Subject: Engineering, Procurement and Construction (EPC) Contract for Renovation and Modernization of Existing Navigational Lock at Farakka, West Bengal.

Reference: IN-IWAI-350002-CW-RFB-2

CPP Portal Tender no: 2023_JMVP_782597_1

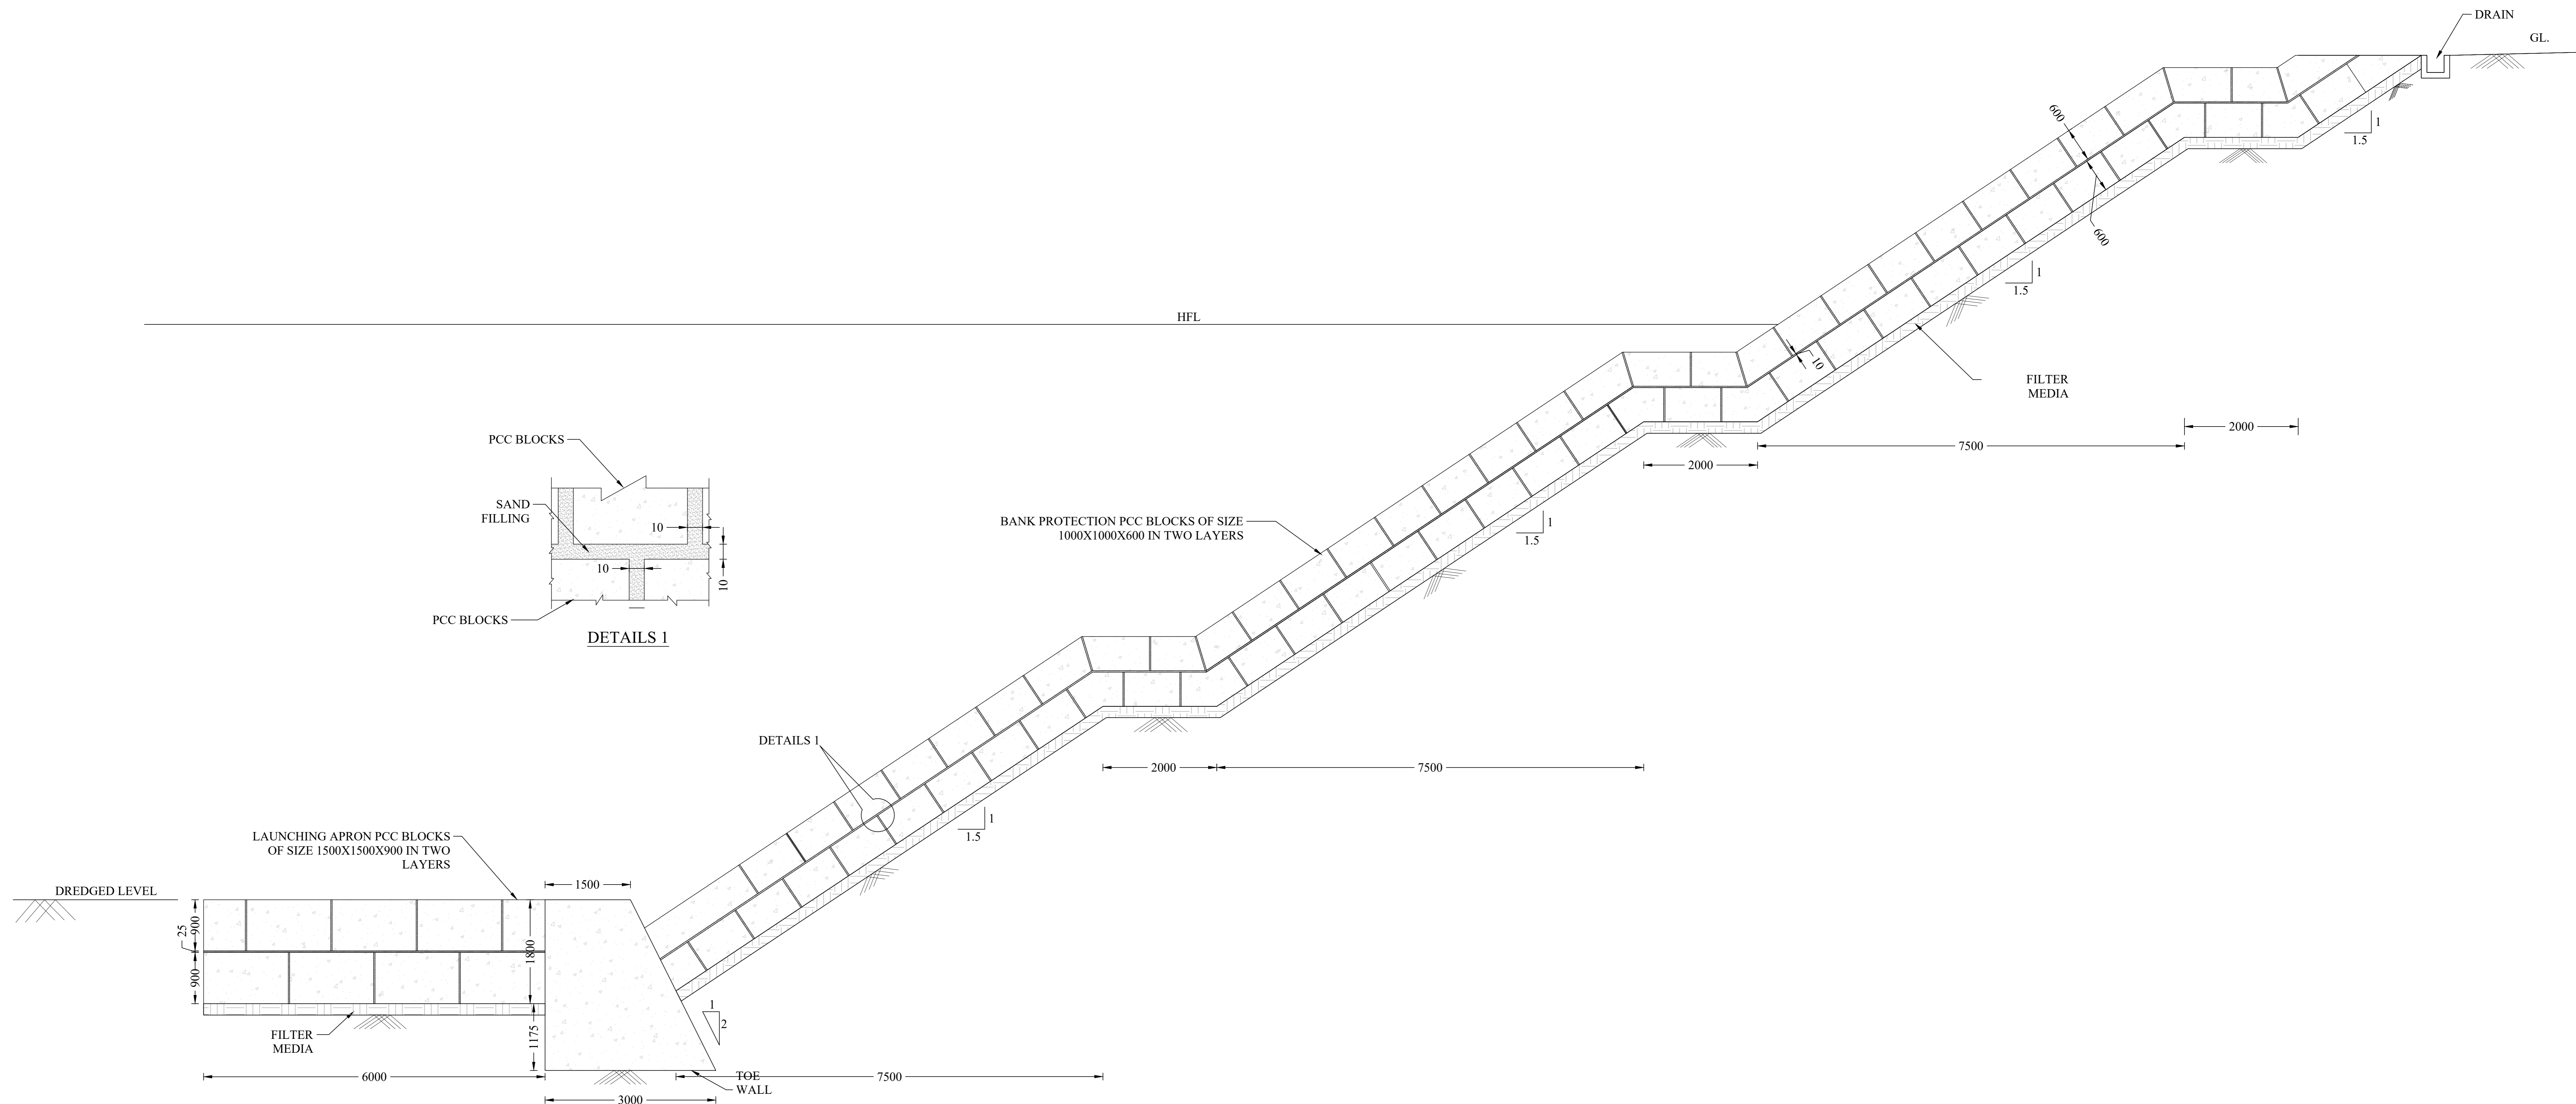
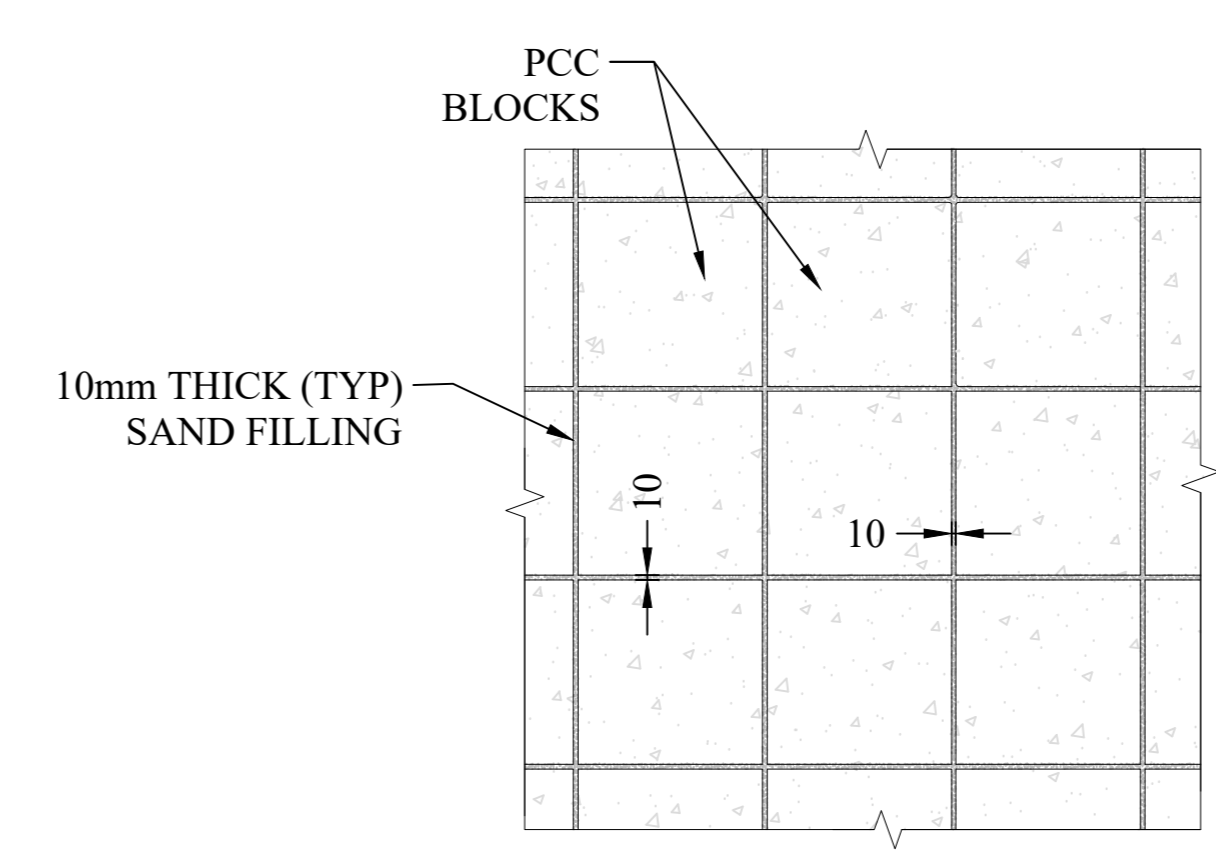
18	Drawings, ENL006, pg 555 of 571	Toe Wall	<p>We need dry surface through the length of the slope protection in order to construct the toe wall. we have to construct coffer dam throughout the length which will affect the navigational channel.</p> <p>Hence bidder requests the employer to descope the toe wall and accept alternate methodology like Gabion Mattress.</p>	<p>Tender conditions prevail. However, latest technologies / materials can be proposed & approval may be obtained from the Employer, keeping in view the aesthetics of the bank protection system on both the banks. The design and safety of the proposed bank protection shall be responsibility of the Contractor.</p>
19	Volume 1: Bid document, pg 42 of 346		<p>Bidder Presumes that qualification requirements and technical proposal shall not be submitted in hard copy. Only online submitted shall be opened.</p> <p>Kindly confirm</p>	<p>Please refer clause no 9 at page no 6 of Notice Inviting tender to understand the submission of hard copy requirement.</p> <p>Entire technical & financial proposal are to be submitted through the CPP portal only.</p> <p>Tender conditions prevail.</p>
